Docket Number:	22-SPPE-01
Project Title:	Bowers Backup Generating Facility
TN #:	250519
Document Title:	Gi Partners Supplemental Responses to Data Request Set 1 DR35 - BBGF
Description:	N/A
Filer:	Scott Galati
Organization:	DayZenLLC
Submitter Role:	Applicant Representative
Submission Date:	6/5/2023 11:58:30 AM
Docketed Date:	6/5/2023

SUPPLEMENTAL RESPONSES TO CEC STAFF DATA REQUEST SET 1 (35)

Bowers Backup Generating Facility (22-SPPE-01)

SITE PLAN FIGURE 2.4

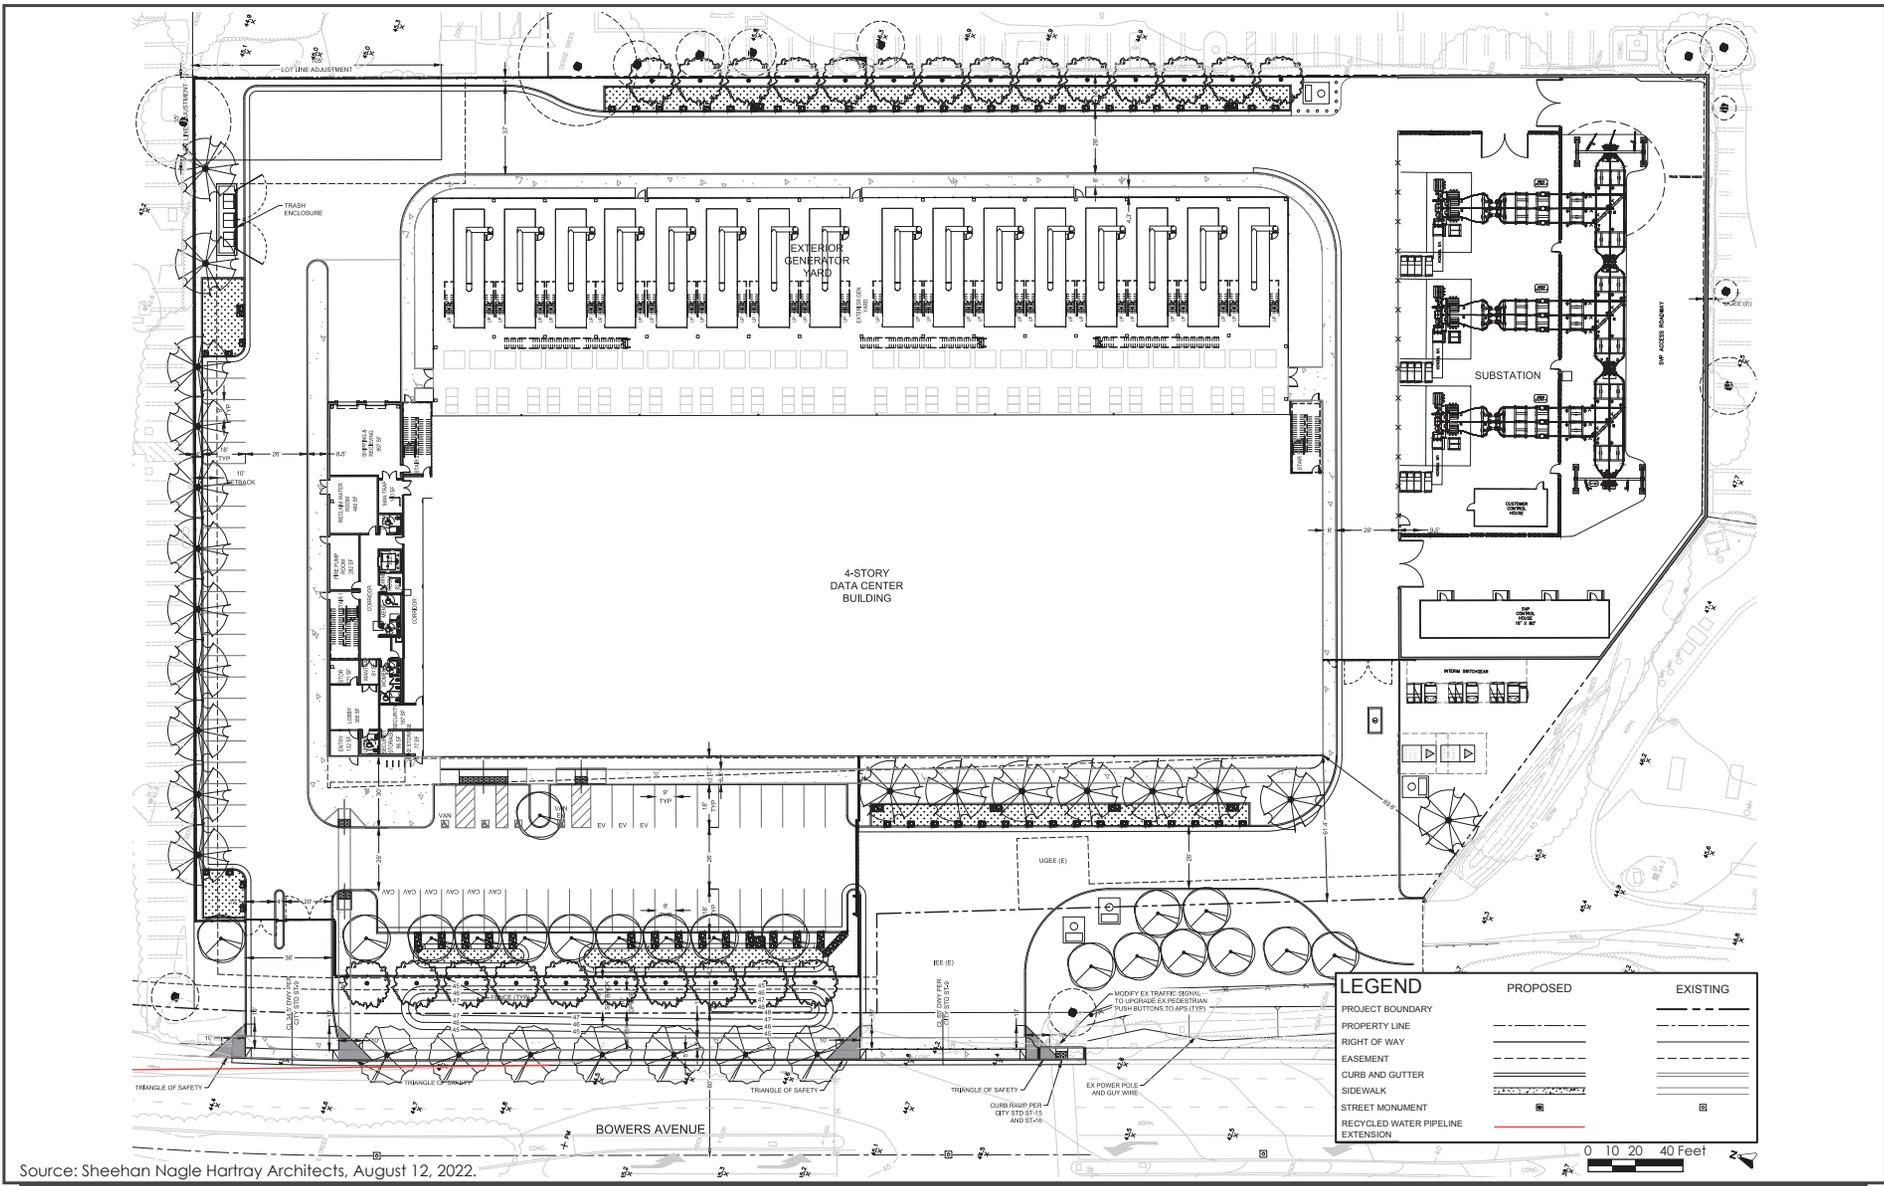
Staff requested Figures included in the original SPPE Application be updated to show the location of the recycled water pipeline. The revised Figures are attached.
